memorandum

Re: The Downs Site Development
Commentary on Dan Burden's Walkability and City Mobility Suggestions

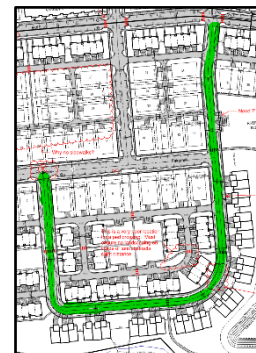
Strictly speaking, this is not an issue that Dan Burden commented upon. We provide this discussion as a follow-up to that of ROW. It appears that Fairbrook, Hutton, and Griswold will be extended as public streets and the balance of the streets and all alleys will be private. But this leaves the public street network a bit disjointed and point up enforcement issues for right of way controls (STOP / YIELD) and speed limits on private streets. OHM recommends that one additional street be considered public jurisdiction, as shown in the adjacent sketch highlighted in green:
